ASSESSMENT REPORT

Section 96(2) Modification Kurnell Refinery Conversion (SSD 5544 MOD 1) Demolition and Removal of Redundant Refinery Process Units, Tanks, Pipelines and Infrastructure

Figure 2: Proposed Demolition Works at the Caltex Terminal, Silver Beach and Botany Bay

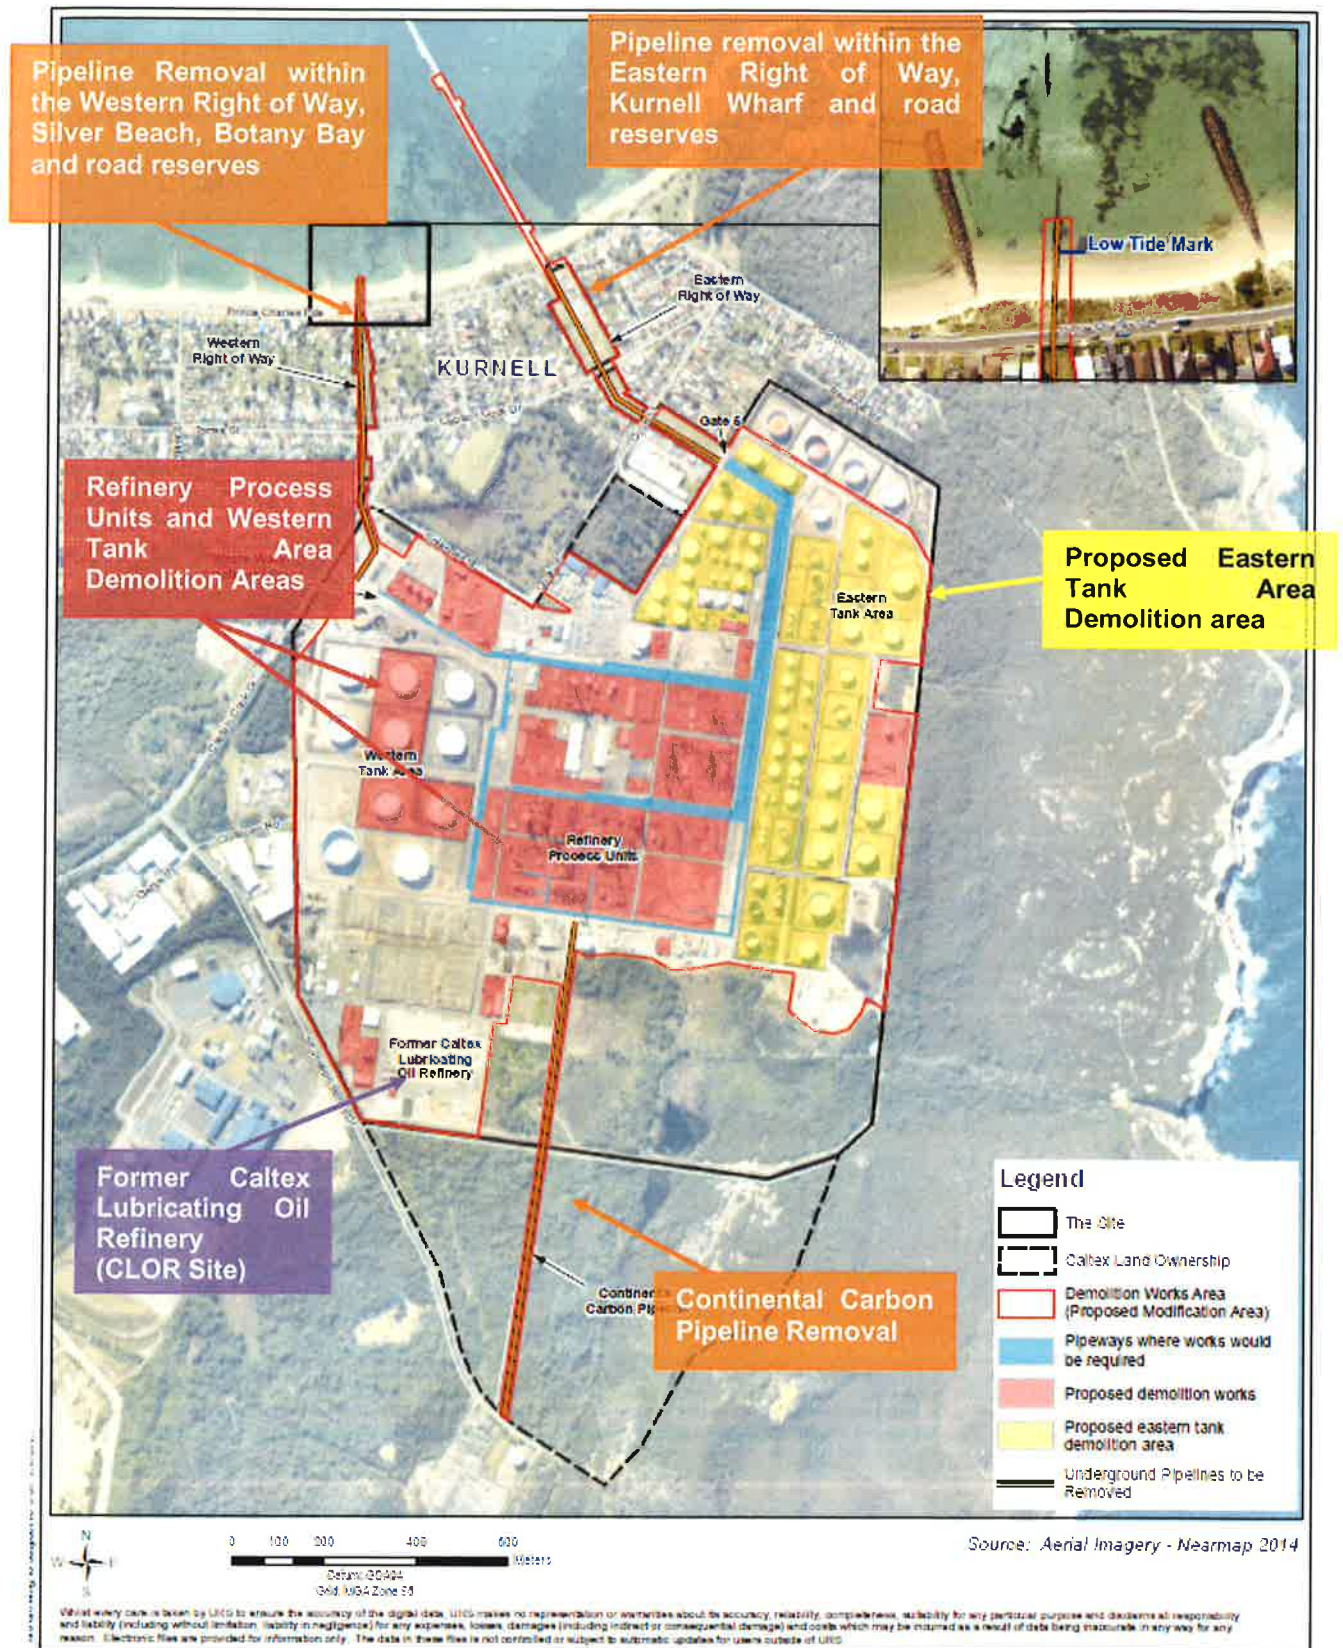
The major components of the modification are shown in **Figure 2** and summarised in **Table 1**. The modification is described in full in URS's Statement of Environmental Effects (SEE), which supports the modification application and is attached in Appendix C.

Figure 3: Location of potential ground disturbance activities

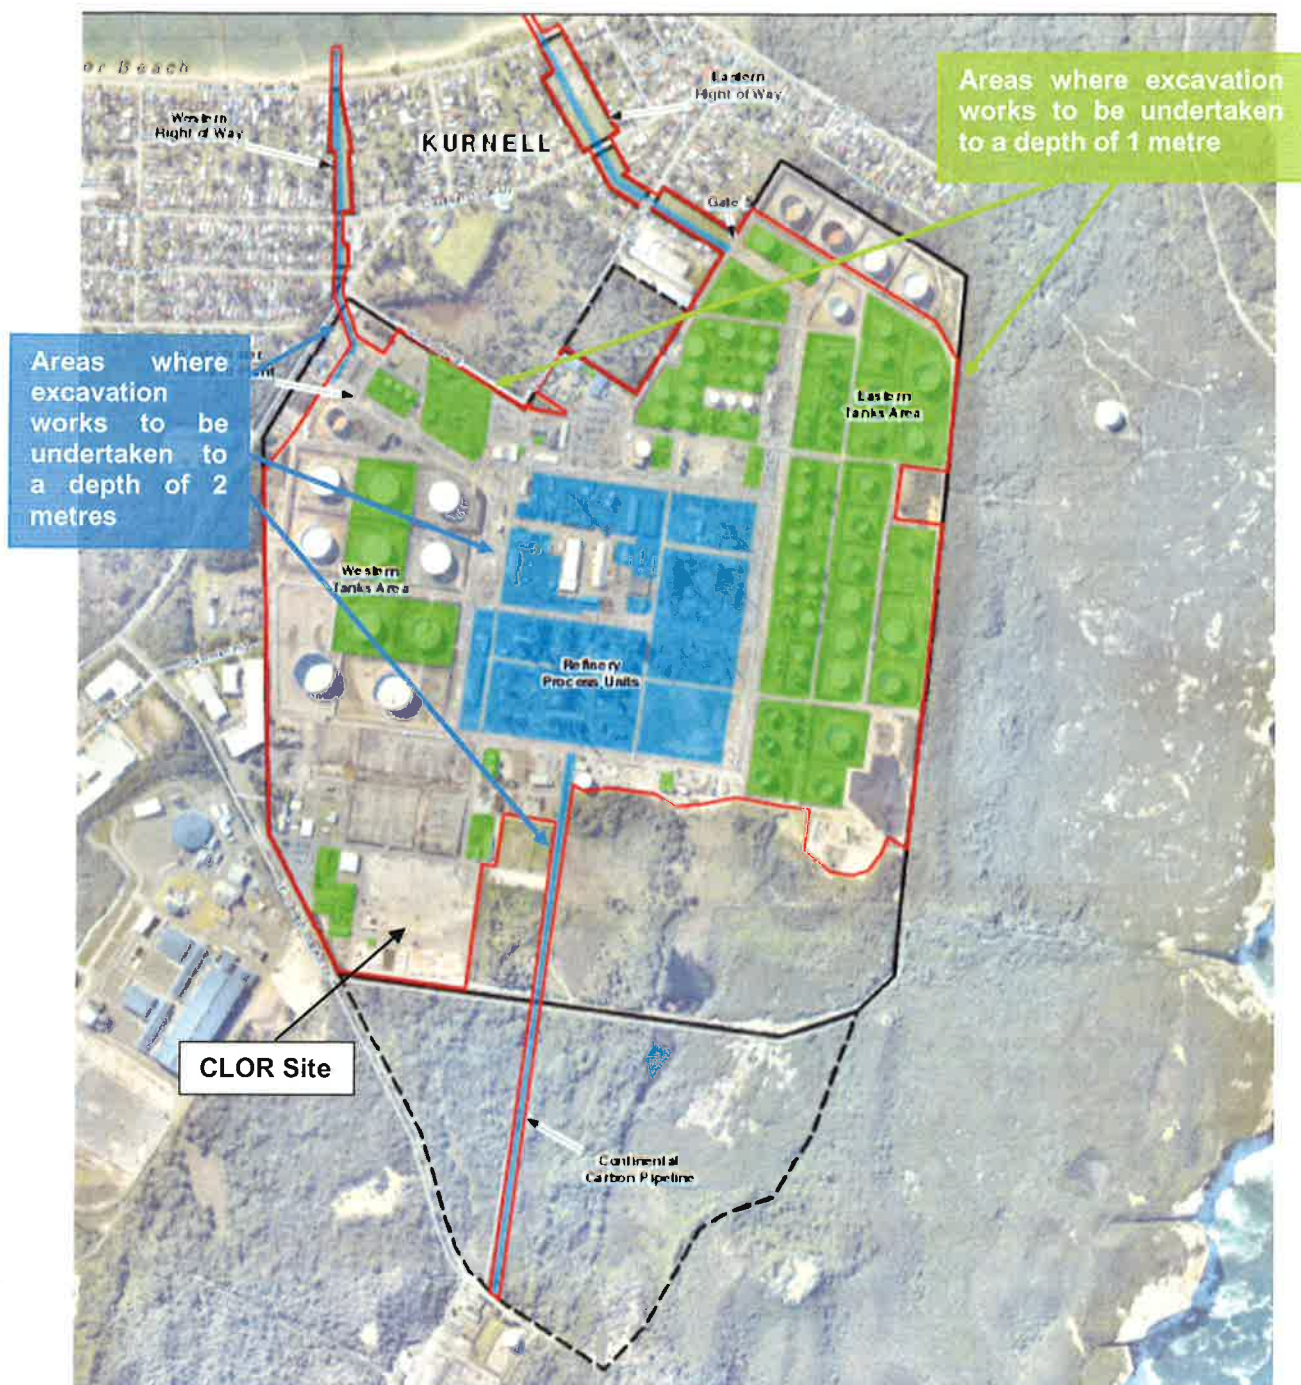
Soils that are considered to be contaminated would be temporarily stored at the former CLOR site which is located in the south west section of the terminal site (See **Figure 3**). These soils would be classified and appropriately banded and managed in the short term in accordance with the terminal site's existing EPL. Where contaminated soils cannot be appropriately managed on-site, it would be taken off-site for disposal at an appropriately licensed facility. The SEE estimates that less than 2,000 tonnes of contaminated soil which cannot be appropriately managed on-site would be taken to a waste disposal facility.

The EPA did not object to the Applicant's overall approach to managing potential soil impacts but sought additional information on the soil classification criteria for soils proposed to be reused as backfill and how stockpiles would be managed during heavy rainfall events. Following consultation with the EPA, the Applicant refined its soil classification methods so that in addition to visual and olfactory inspections, potentially contaminated soils would undergo testing against National Environmental Protection Measures (NEPM) soil criteria. The Applicant also clarified that stockpiles containing contaminated soils would be placed on plastic sheeting and appropriately bunded to ensure that contamination impacts are minimised during heavy rainfall events.

The Department is satisfied with the Applicant's approach to managing the potential soil impacts and notes that the works are temporary and would be undertaken in discrete sections to minimise the excavation areas and stockpiles required at any one time. The Department also considers that the management and temporary stockpiling of contaminated soils in the CLOR site is appropriate for the duration of the demolition works given that the terminal site is likely to undergo remediation at a later

The Department is also satisfied that soils which are suitable for reuse can be used as backfill within the terminal site. However, it also considers that any soils to be used for backfilling activities in the Eastern and Western ROWs should only be Virgin Excavated Natural Materials (VENM) or any other material approved in writing by the EPA to ensure that potentially contaminated soils are not used.
